CALL NO. 101  
CONTRACT ID NO. 111313  
ADDENDUM # 1

Subject: Jefferson County, HPP 0163 (032)  
Letting April 22, 2011

**The Parklands of Floyds Fork - Project 2A**  
 Backley Creek Park - North  
 Louisville, Kentucky

MODIFICATIONS TO CONTRACT DOCUMENTS:

**WALL 1  
LAYOUT &  
DETAILS**  
Drawing No:  
**SW-1001**

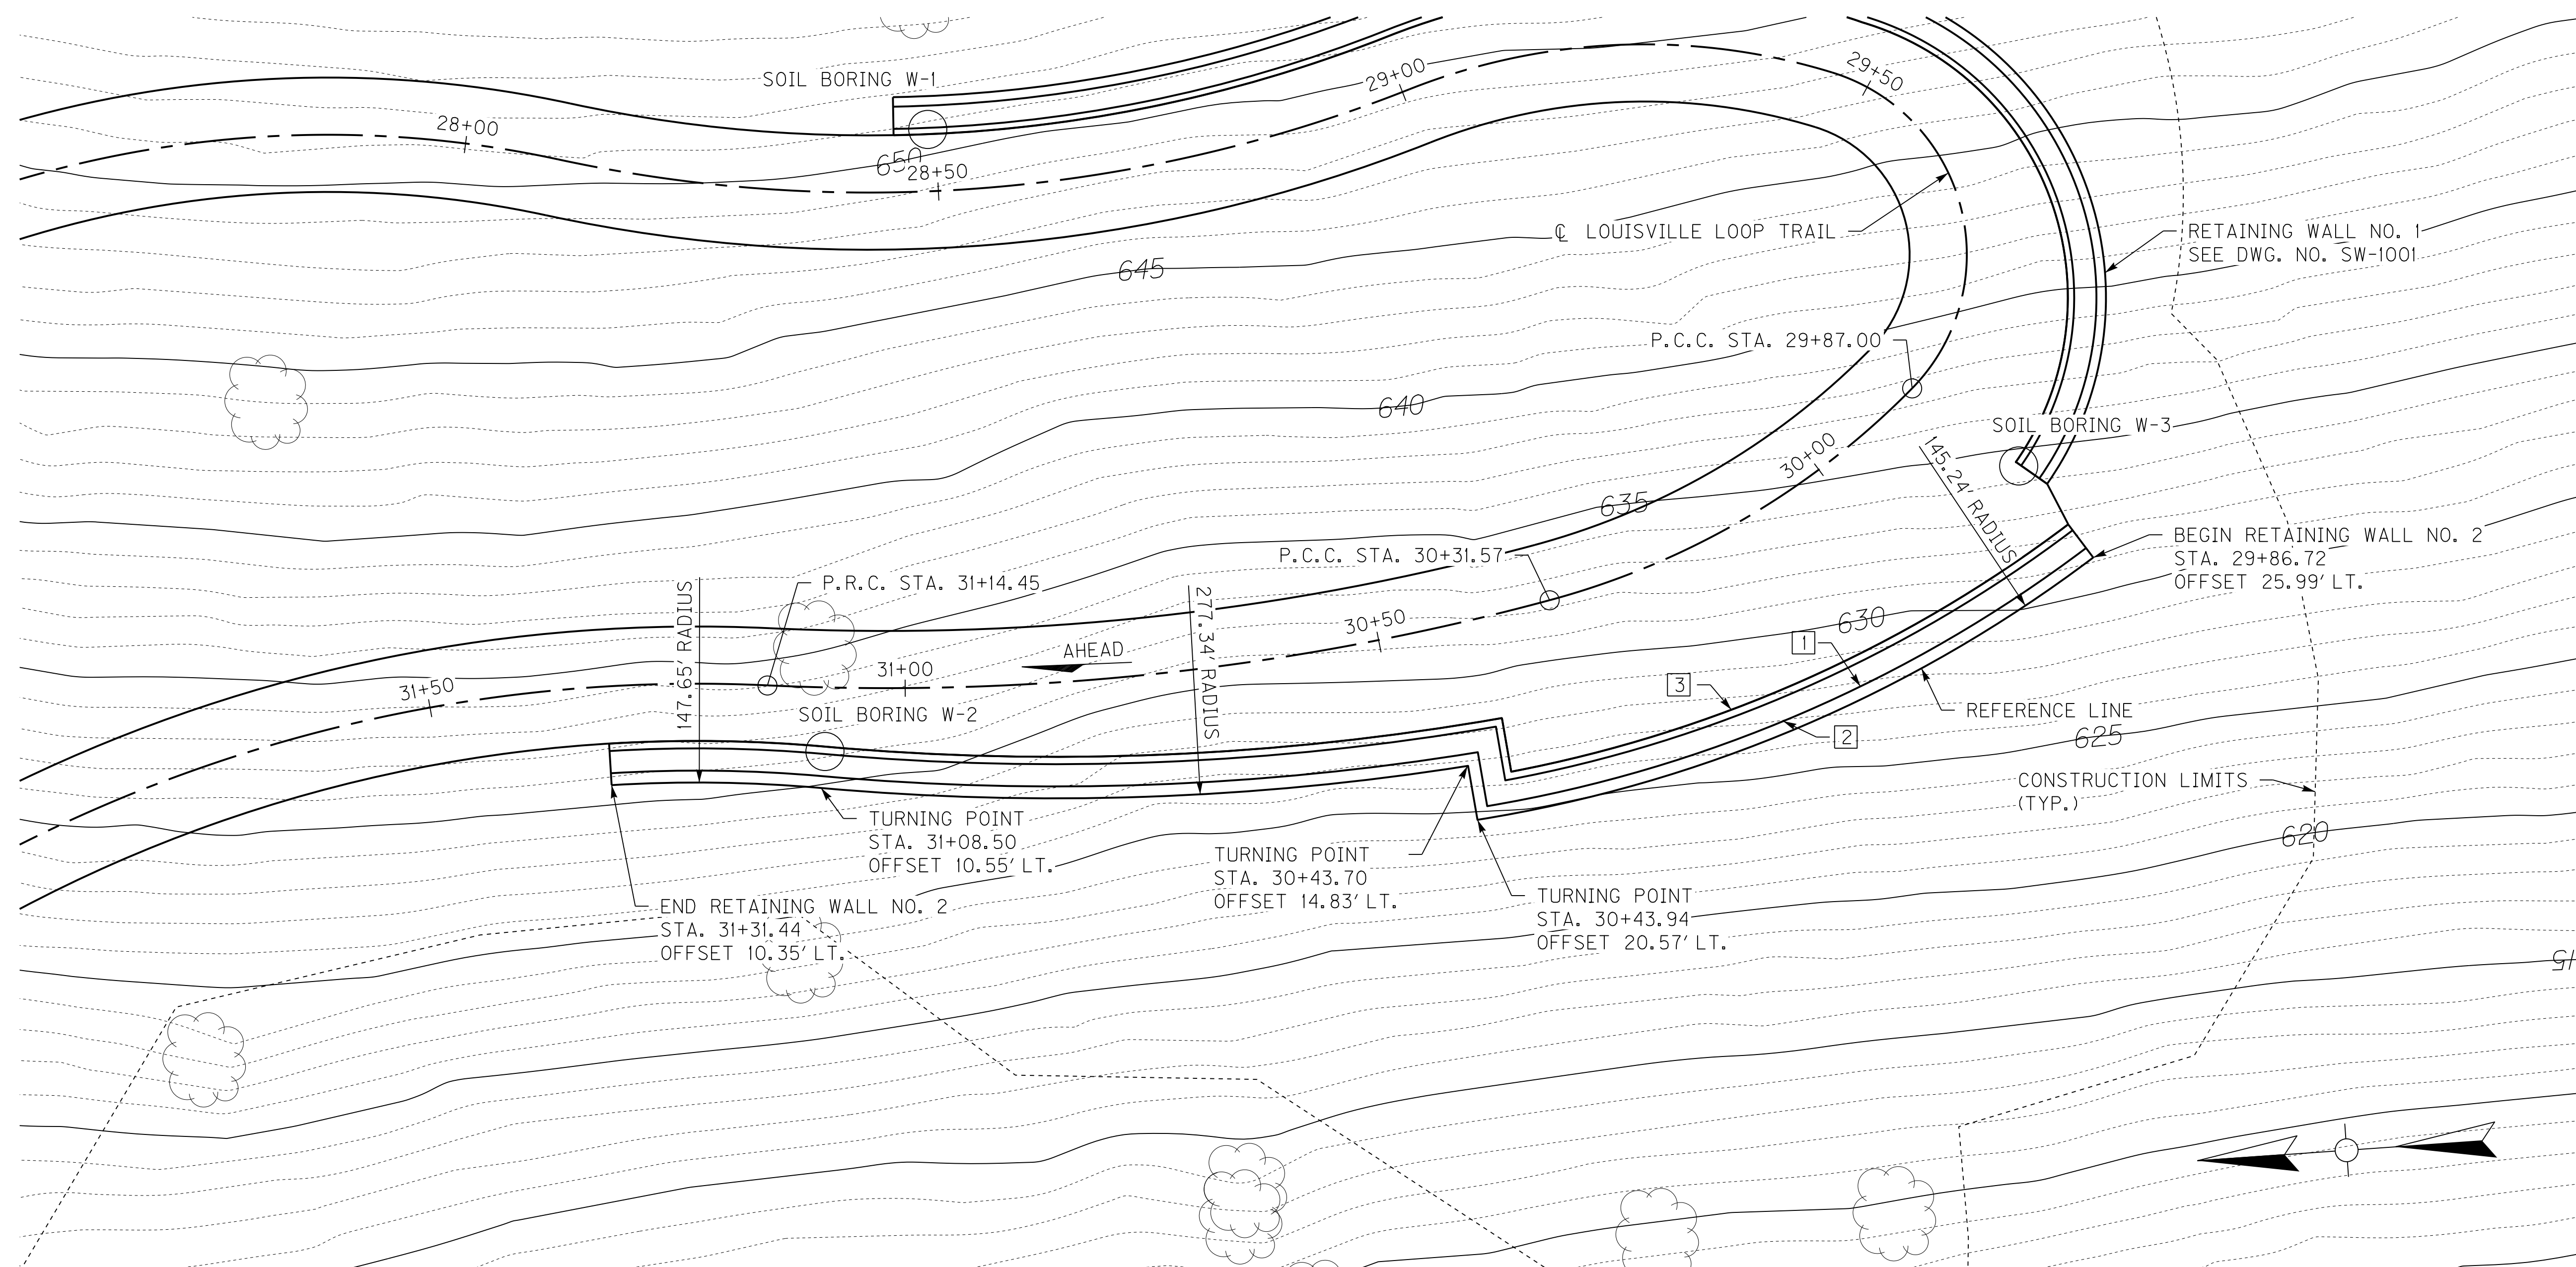
- SW-1001 Revised note to read “The wall block system shall be the Ledgestone series with color scheme “Kentuckiana Buff” as manufactured by Redi-Rock of Kentuckiana, Mt. Washington, KY., or approved equal.
- SW-2001 Revised note to read “The wall block system shall be the Ledgestone series with color scheme “Kentuckiana Buff” as manufactured by Redi-Rock of Kentuckiana, Mt. Washington, KY., or approved equal.
- SW-3001 Revised note to read “The wall block system shall be the Ledgestone series with color scheme “Kentuckiana Buff” as manufactured by Redi-Rock of Kentuckiana, Mt. Washington, KY., or approved equal.
- SW-6001 Revised note to read “The wall block system shall be the Ledgestone series with color scheme “Kentuckiana Buff” as manufactured by Redi-Rock of Kentuckiana, Mt. Washington, KY., or approved equal.
